SCHEDULE 'F'

PV-145 see attached
December 10, 2020

The Hillsdale
40' SERIES

GROUND FLOOR | ELEV. A

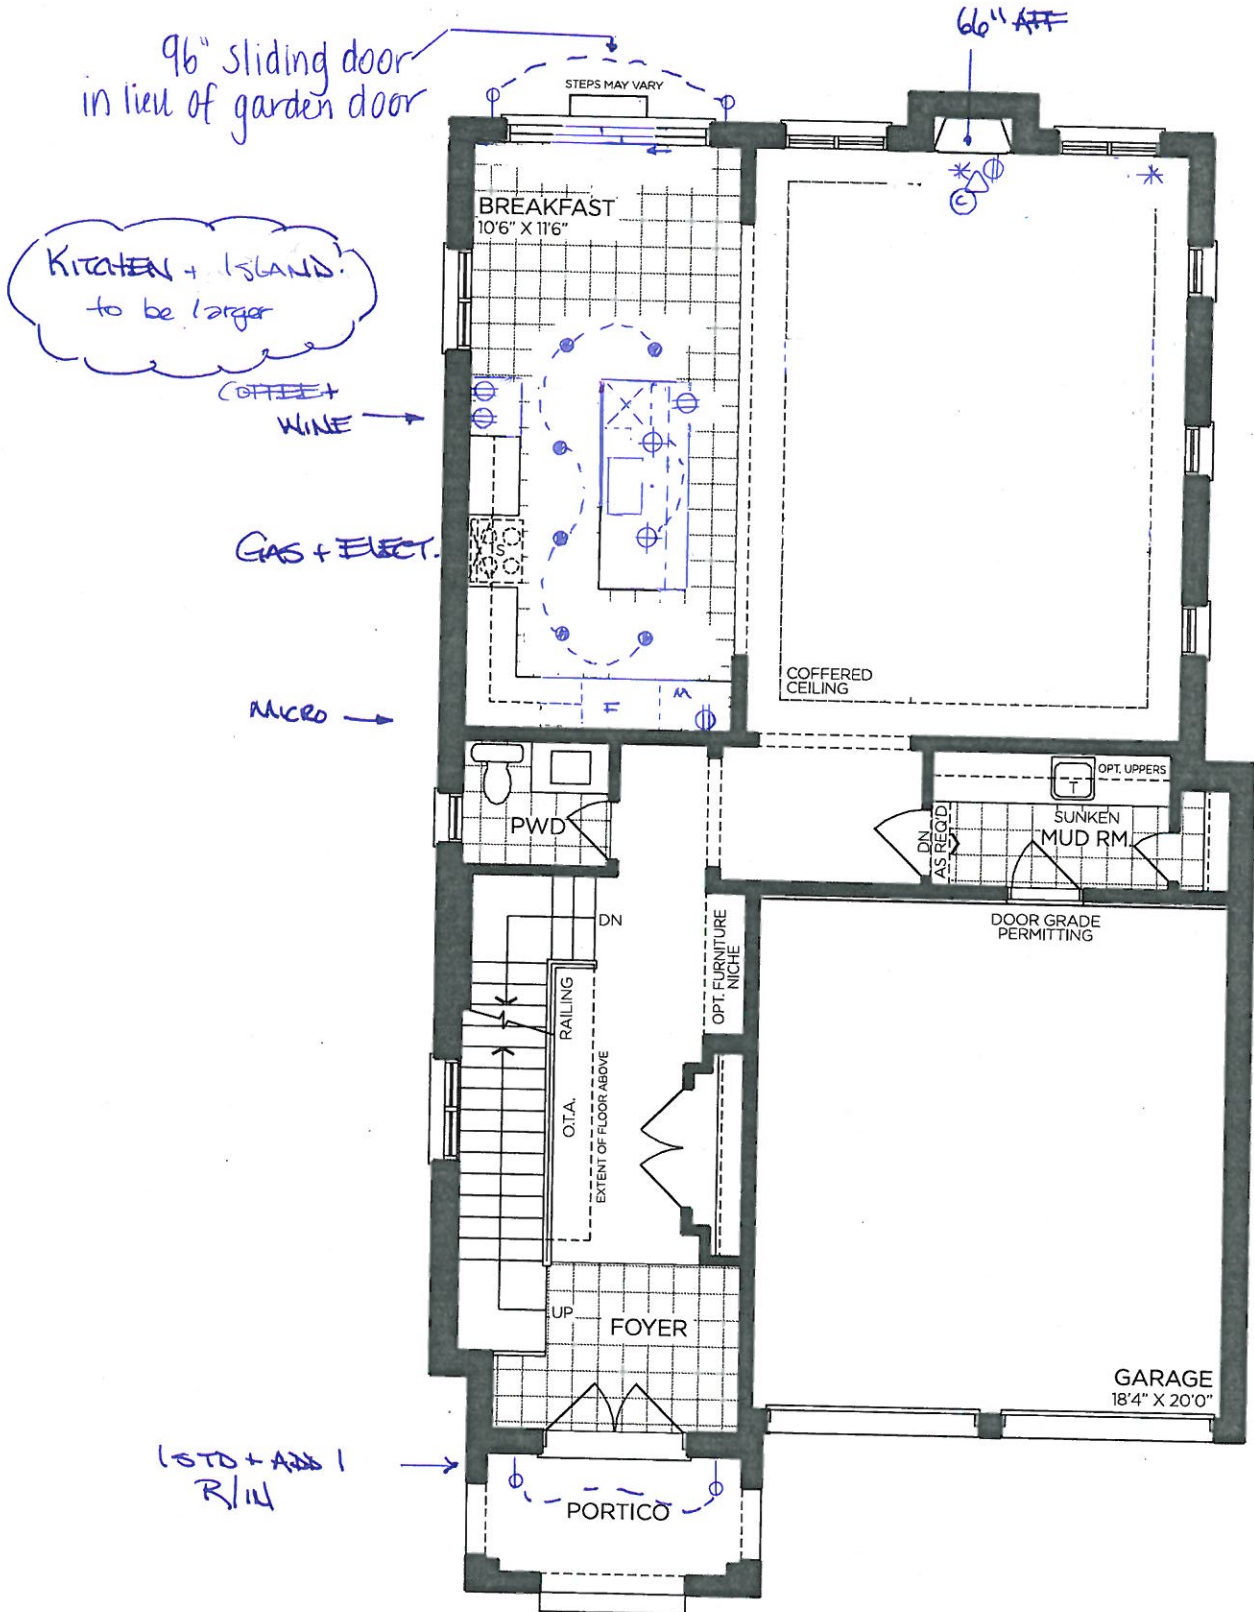
2472 72,288 16Dec20	1	SHARED ENSUITE: ROUGH-IN FOR ADDITIONAL WALL SCONCE (1) CAPPED OUTLET ON EXISTING SWITCH - FIXTURE NOT INCLUDED RELOCATE STANDARD VANITY LIGHT TO ABOVE 1 SINK + ADD 1 ROUGH-IN ABOVE OTHER SINK - USE STANDARD SWITCH
2472 72,292 16Dec20	1	FRONT FOYER: ADDITIONAL EXTERIOR COACH LIGHT ON SAME SWITCH (BUILDERS STANDARD FIXTURE) OPPOSITE SIDE OF FRONT DOOR, SAME HEIGHT AND SWITCH AS STANDARD
2472 72,292 16Dec20	1	REAR ELEVATION: ADDITIONAL EXTERIOR COACH LIGHT ON SAME SWITCH (BUILDERS STANDARD FIXTURE) - OPPOSITE SIDE OF DOOR, SAME HEIGHT AND SWITCH AS STANDARD
2472 72,307 16Dec20	1	KITCHEN: FIXTURE: RELOCATE STANDARD CEILING MOUNT FIXTURE LOCATE APPROX CENTERED ABOVE ISLAND
2472 72,280 16Dec20	1	KITCHEN: CEILING OUTLET: ADDITIONAL REINFORCED CEILING OUTLET - APPROX CENTERED ABOVE ISLAND USE SAME SWITCH AS STANDARD

Invoice	Qty.	Description
2472 72,639 16Dec20	1	**CUSTOM LAYOUT** MASTER BEDROOM CLOSET: UPGRADE TO DOUBLE *POCKET* DOORS, COMPLETE WITH BUILDERS STANDARD OFFERINGS
2472 16Dec20 NoCat	1	**CUSTOM LAYOUT** MASTER BEDROOM - DELETE DOUBLE DOOR ENTRY, RELOCATE DOOR AND INSTALL SINGLE DOOR INSTEAD
2472 16Dec20 NoCat	1	.BREAKFAST: UPGRADE DOOR TO 96" SLIDING DOOR (in lieu of garden door)

Invoice	Qty.	Description
2472 16Dec20 NoCat	1	**NOTE** KITCHEN TO BE LONGER - ADDITIONAL CABINETRY AND COUNTER TO BE ADDED AT COLOURS ORDER
2472 16Dec20 NoCat	1	.KITCHEN: **NOTE** SINK TO BE CENTERED ON ISLAND, DISHWASHER TO LEFT OF SINK

Invoice	Qty.	Description
2472 16Dec20 NoCat	1	.FRONT FOYER: ADDITIONAL EXTERIOR COACH LIGHT ON SAME SWITCH (BUILDERS STANDARD FIXTURE) .OPPOSITE SIDE OF FRONT DOOR, SAME HEIGHT AND SWITCH AS STANDARD
2472 16Dec20 NoCat	1	.REAR ELEVATION: ADDITIONAL EXTERIOR COACH LIGHT ON SAME SWITCH (BUILDERS STANDARD FIXTURE) - .OPPOSITE SIDE OF DOOR, SAME HEIGHT AND SWITCH AS STANDARD

SECOND FLOOR | ELEV. A

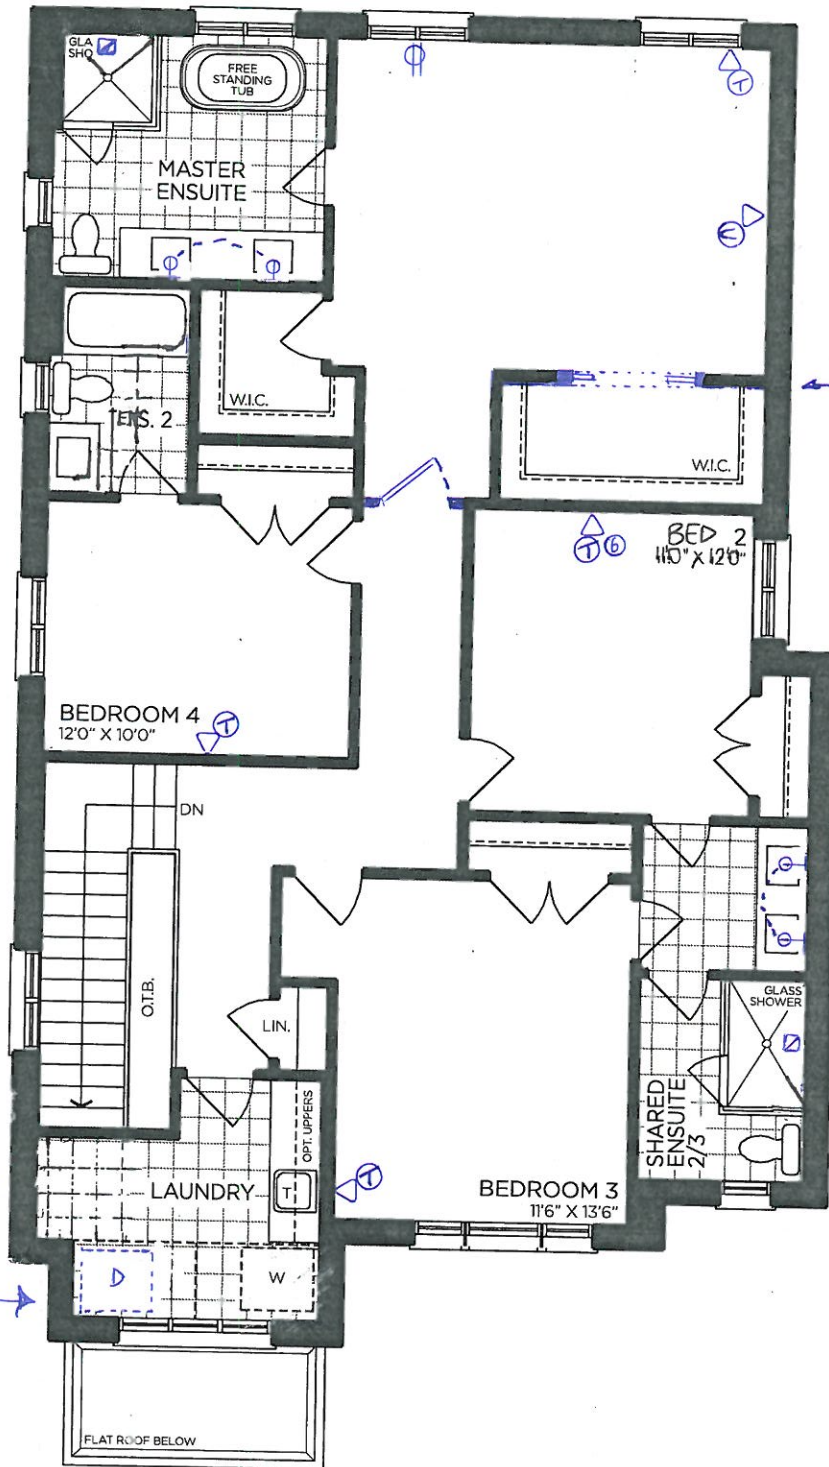
Invoice	Qty.	Description
2472 16Dec20 NoCat	1	**CUSTOM LAYOUT** MASTER BEDROOM - DELETE DOUBLE DOOR ENTRY, RELOCATE DOOR AND INSTALL SINGLE DOOR INSTEAD
2472 72,631 16Dec20	1	MASTER ENSUITE: SHOWER NICHE [SHAMPOO SHELF] - COMPLETE WITH MATCHING MARBLE JAMBS ON 4 SIDES, STANDARD TILE, APPROX. 12 X 18 INSTALLED VERTICALLY
2472 72,631 16Dec20	1	SHARED ENSUITE: SHOWER NICHE [SHAMPOO SHELF] - COMPLETE WITH MATCHING MARBLE JAMBS ON 4 SIDES, STANDARD TILE, APPROX. 12 X 18 INSTALLED VERTICALLY
2472 16Dec20 NoCat	1	.BREAKFAST: UPGRADE DOOR TO 96" SLIDING DOOR (in lieu of garden door)
2472 16Dec20 NoCat	1	**CUSTOM LAYOUT** MASTER BEDROOM CLOSET: UPGRADE TO DOUBLE *POCKET* DOORS, COMPLETE WITH BUILDERS STANDARD OFFERINGS

Invoice	Qty.	Description
2472 72,224 16Dec20	1	KITCHEN: GAS LINE ROUGH-IN - MAIN FLOOR FOR APPLIANCE - SEE PLAN FOR LOCATION
2472 16Dec20 NoCat	1	**CUSTOM LAYOUT** LAUNDRY: REVISE LAYOUT - RELOCATE DRYER ROUGH-IN TO OPPOSITE WASHING MACHINE BASED ON SITE APPROVAL

Double Pocket Doors

Relocate Dryer

Patio Door
08 x 08 Configuration

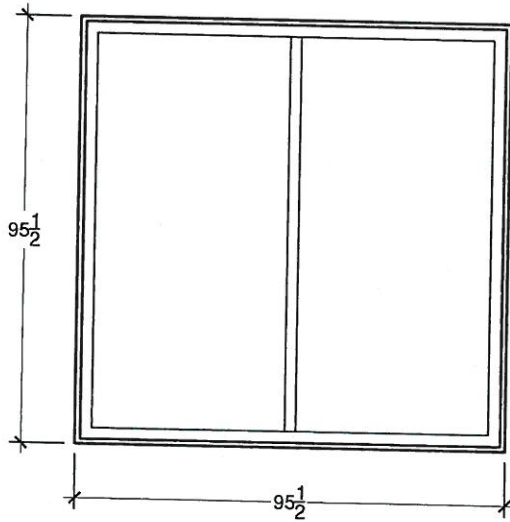
2472 16Dec20 NoCat	1	BREAKFAST: UPGRADE DOOR TO 96" SLIDING DOOR (in lieu of garden door)
------------------------------	---	--
